Product Announcement

Improved Limit System for MTH/MTBH Electronic Operators

Manaras-Opera's Improved Limit System

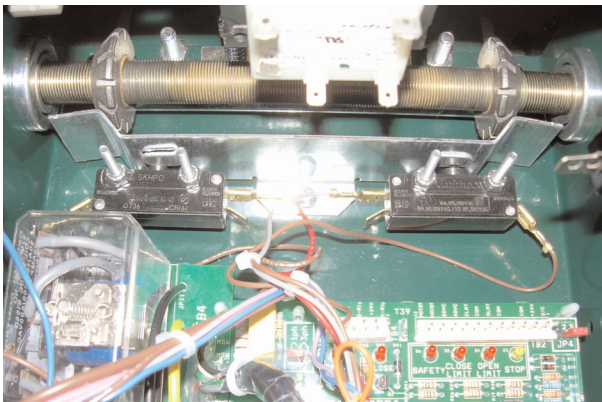
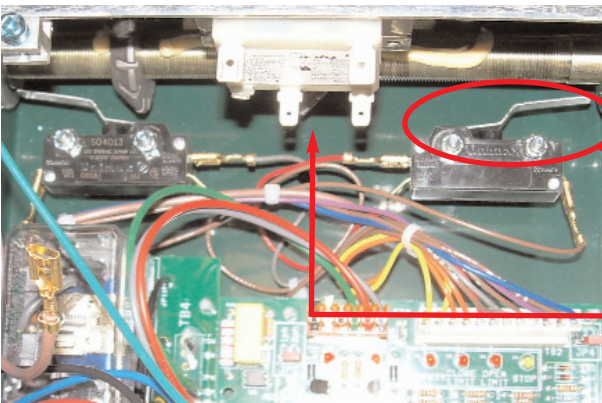
Limit System as it used to be ▶▶▶

New Improved Limit System ▶▶▶

- Unique central lever has been eliminated.
- Each limit now has an independent lever which is specifically formed for a more consistent activation.
